MOD2024/0233

Project:
"THE ORCHARD"
CHILDCARE CENTRE
723-727 WARRINGAH ROAD
FORESTVILLE

Title:
PROPOSED GROUND FLOOR

PROPOSED MODIFICATION

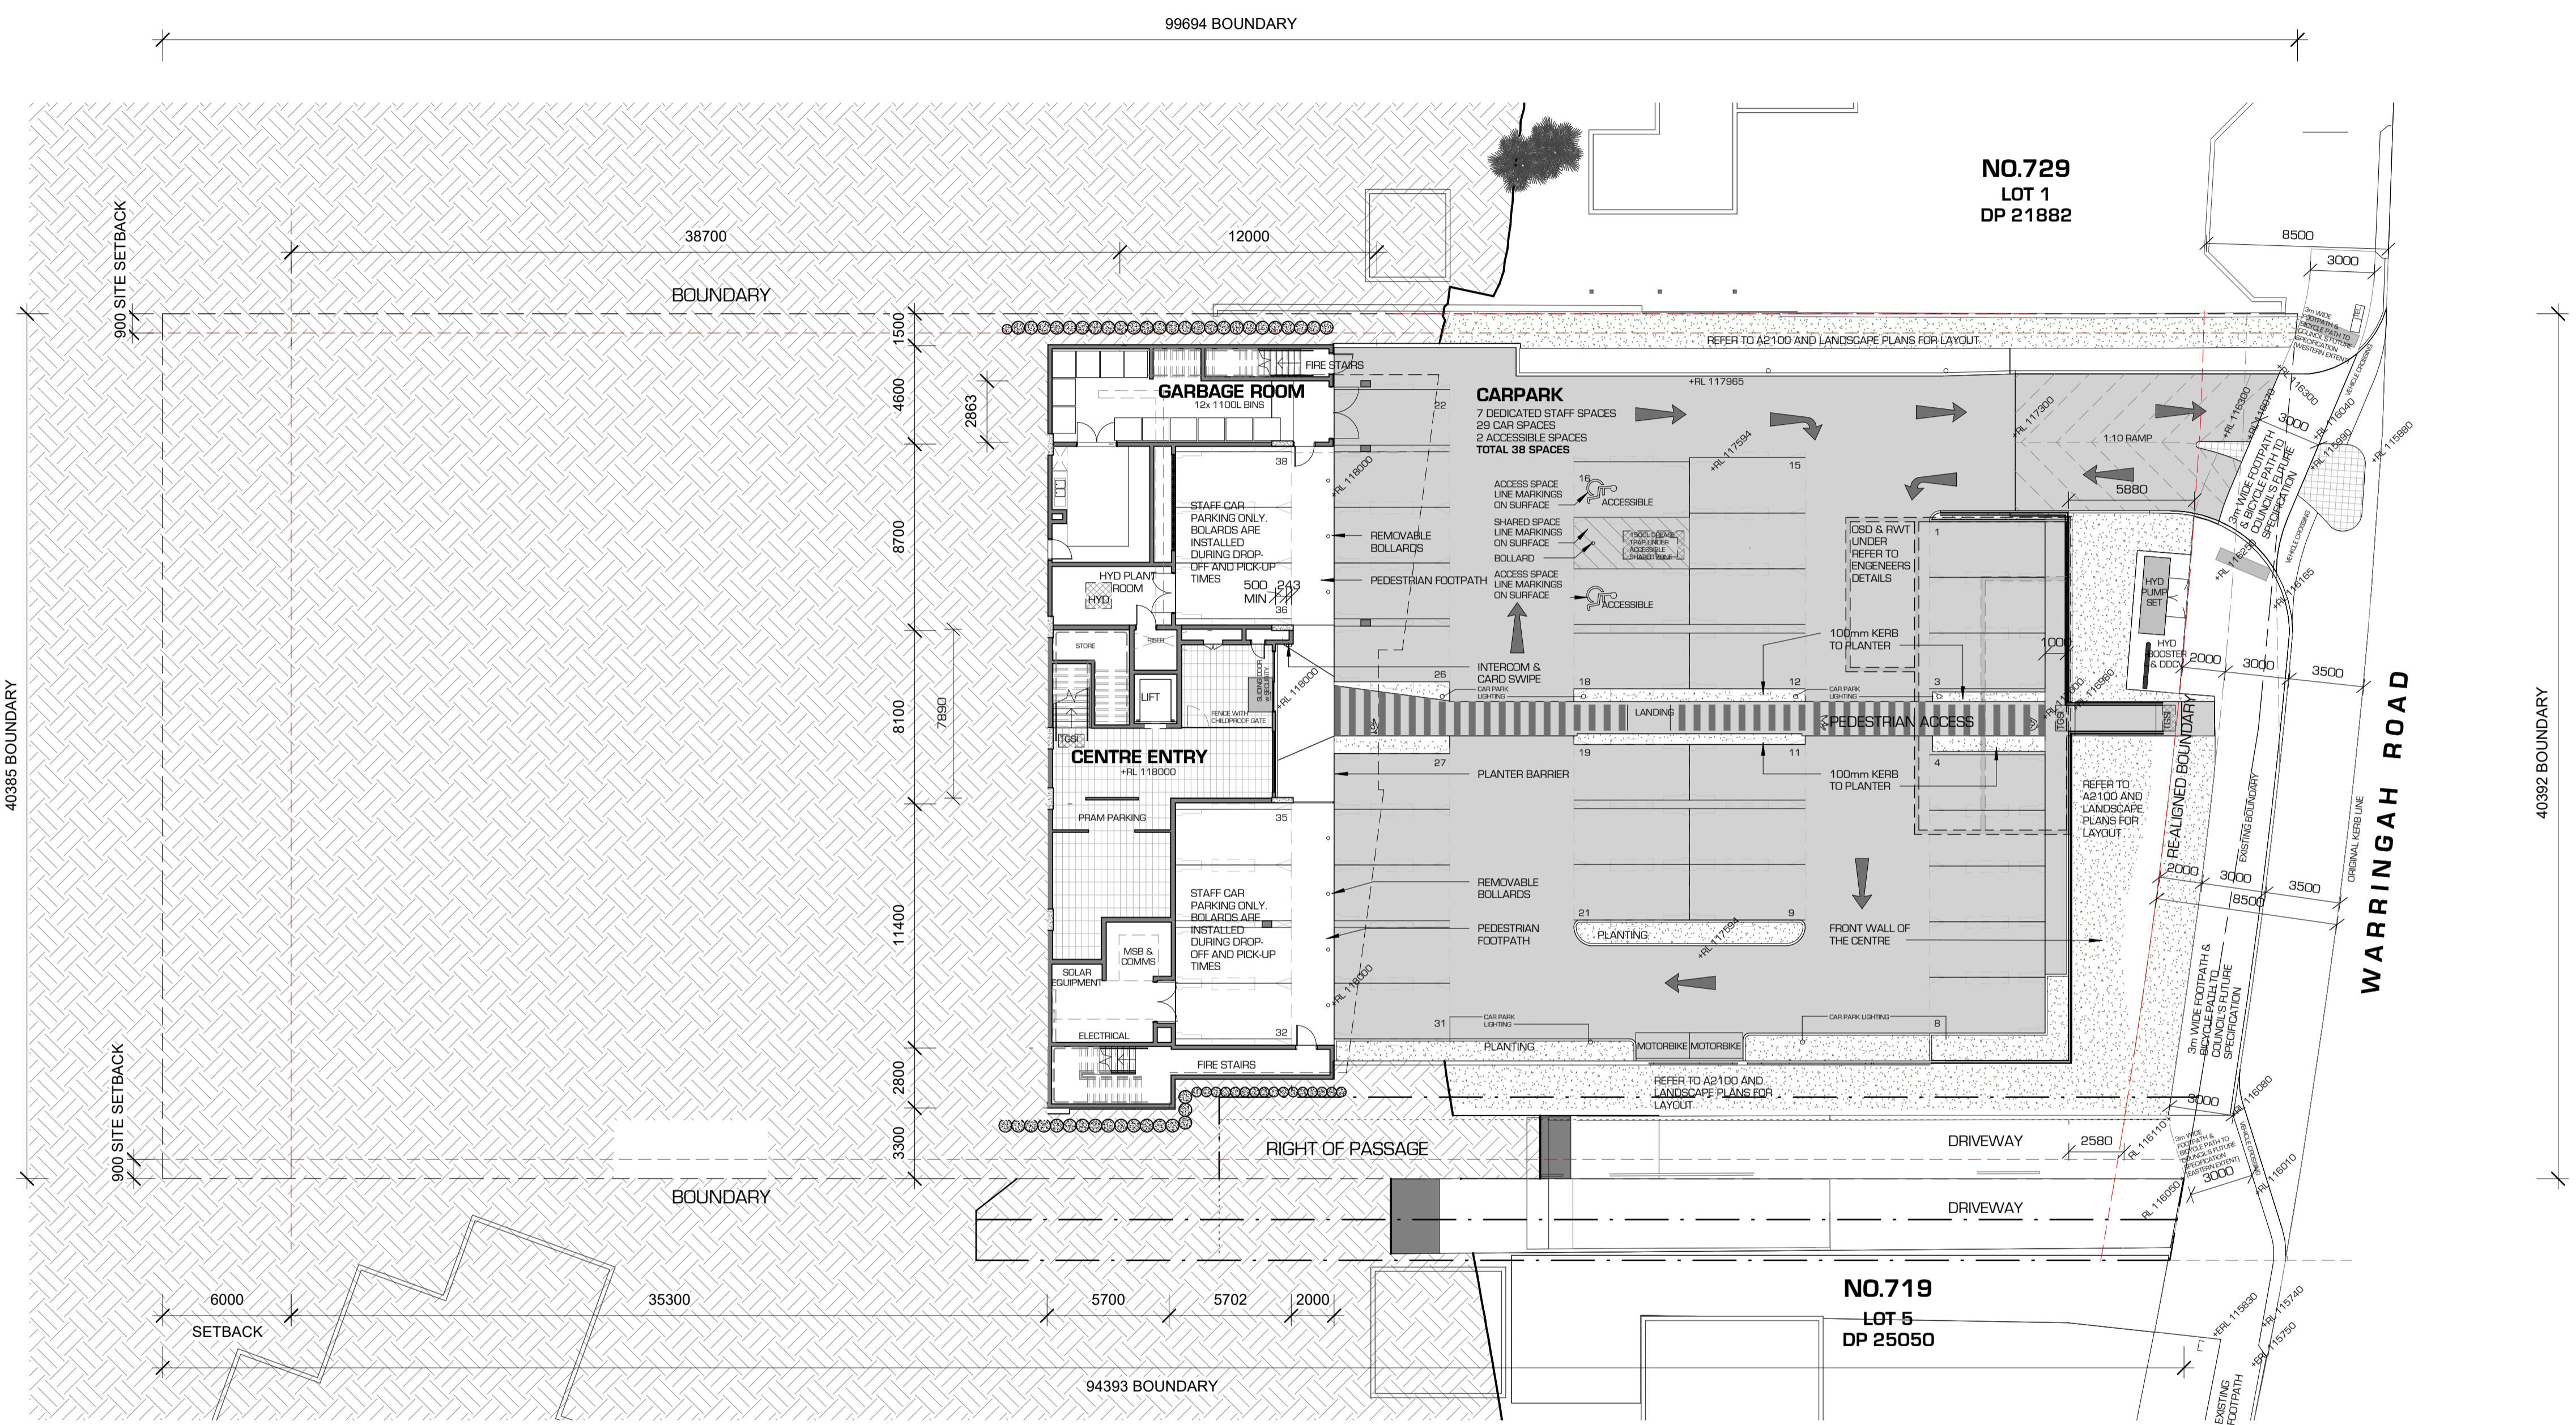
NOTE:
EXTERNAL ENVELOPE OF THE PROPOSED BUILDING REMAINS UNCHANGED.
THE EXTENT OF EXCAVATION HAS BEEN AMENDED COVER WAS REMOVED TO THE EXTENT POSSIBLE OVER THE LEVEL 1 OUTDOOR SPACE AND THE WESTERLY GLAZED WALL IS PROPOSED AS A BALUSTRADE.

Title:
PROPOSED LEVEL 1

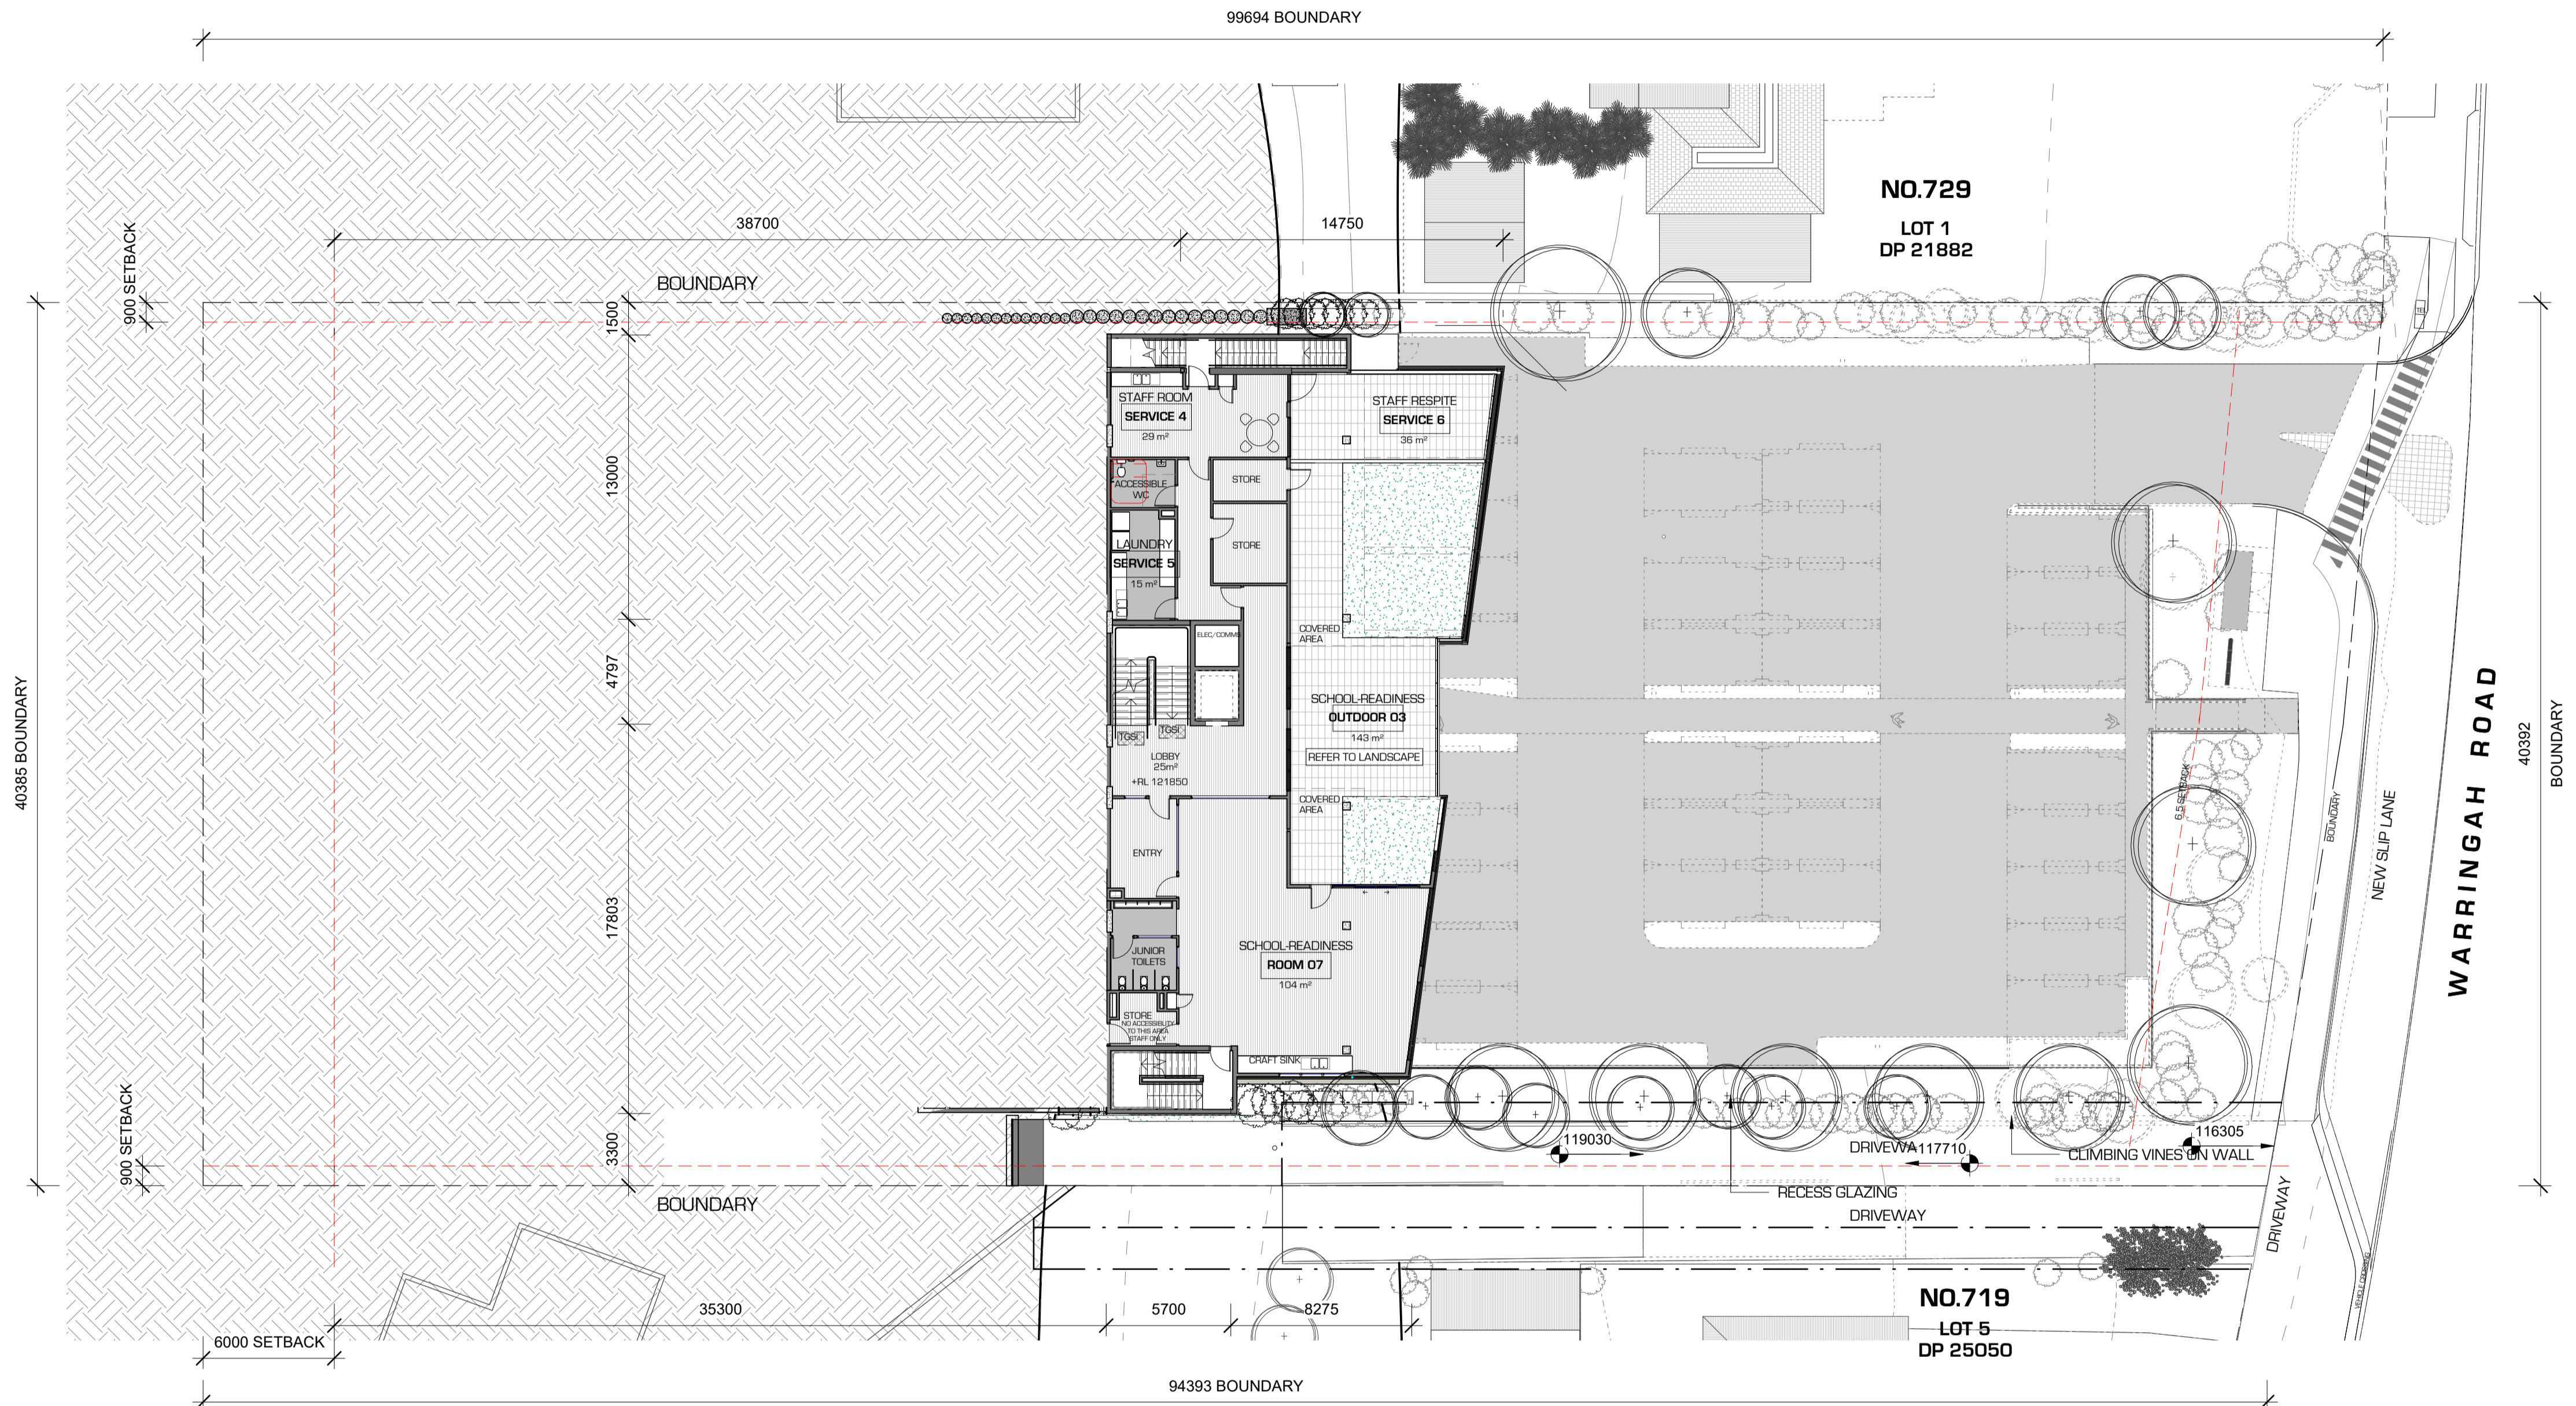
NOTE
EXTERNAL ENVELOPE OF THE PROPOSED BUILDING REMAINS UNCHANGED
THE EXTENT OF EXCAVATION HAS BEEN AMENDED COVER WAS REMOVED TO THE EXTENT POSSIBLE OVER THE LEVEL 1 OUTDOOR SPACE AND THE WESTERLY GLAZED WALL IS PROPOSED AS A BALUSTRADE.

PROPOSED LEVEL 2

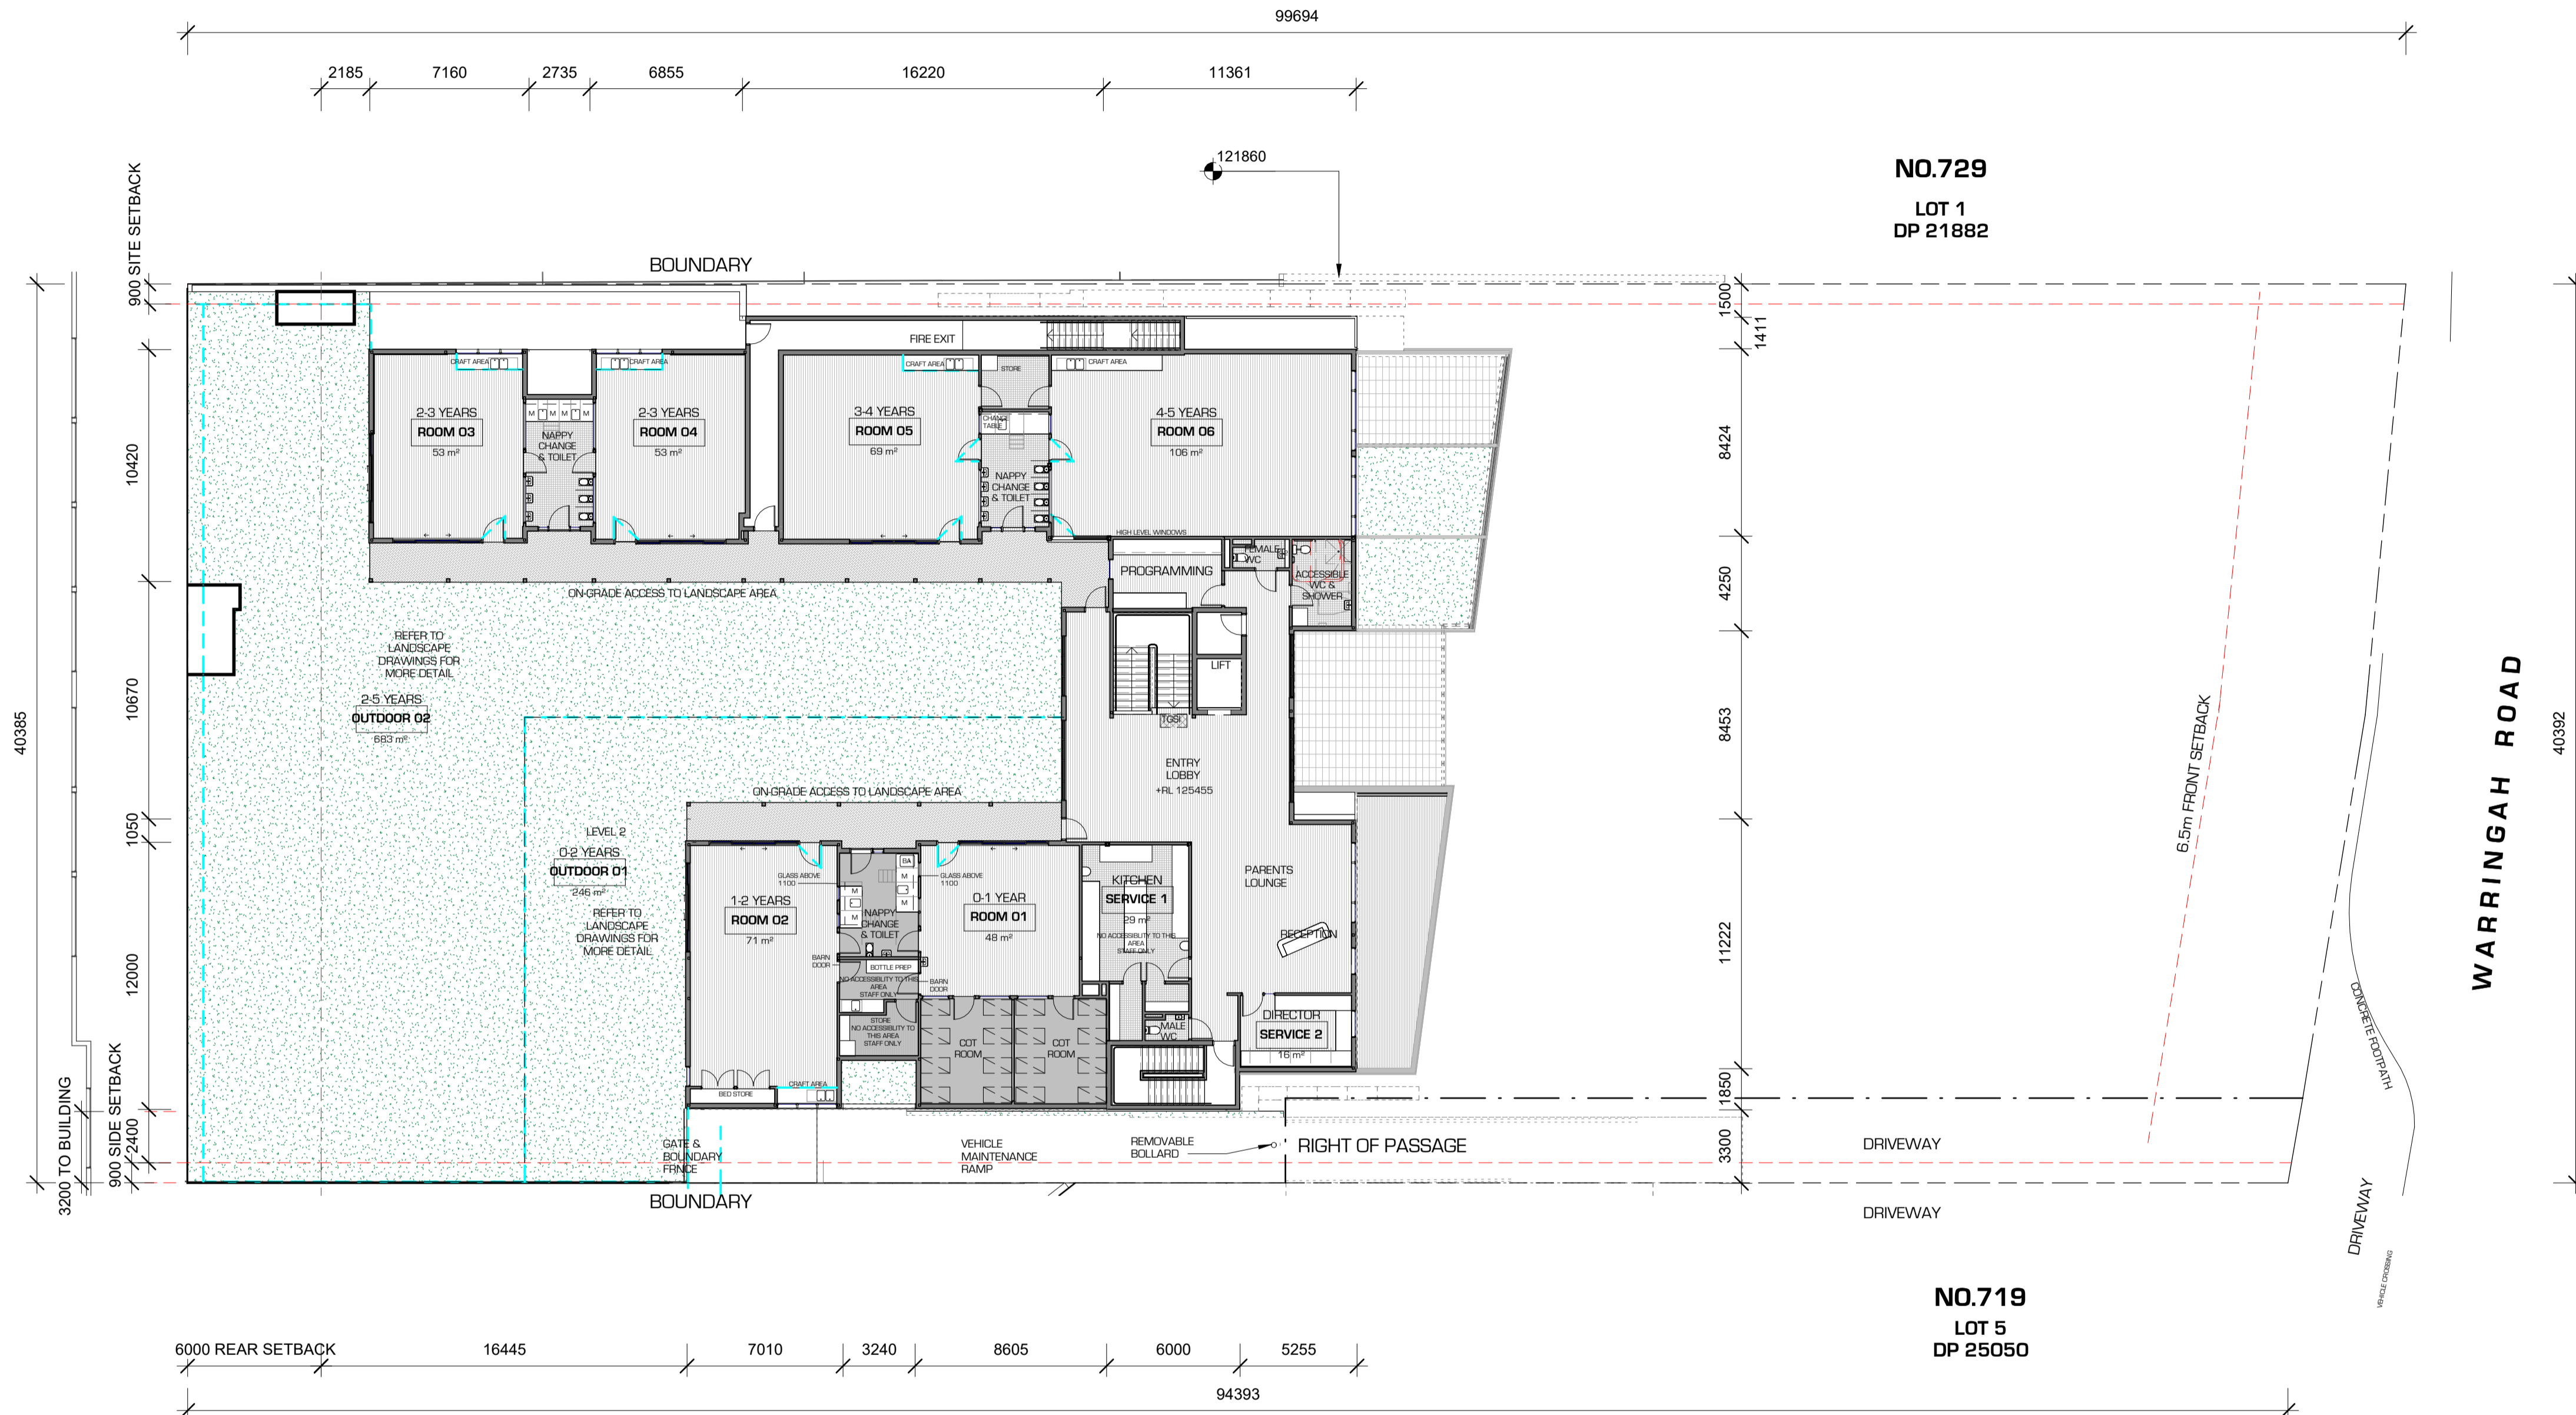
NOTE
 EXTERNAL ENVELOPE OF THE PROPOSED BUILDING REMAINS UNCHANGED
 THE EXTENT OF EXCAVATION HAS BEEN AMENDED COVER WAS REMOVED TO THE EXTENT POSSIBLE OVER THE LEVEL 1 OUTDOOR SPACE AND THE WESTERLY GLAZED WALL IS PROPOSED AS A BALUSTRADE.
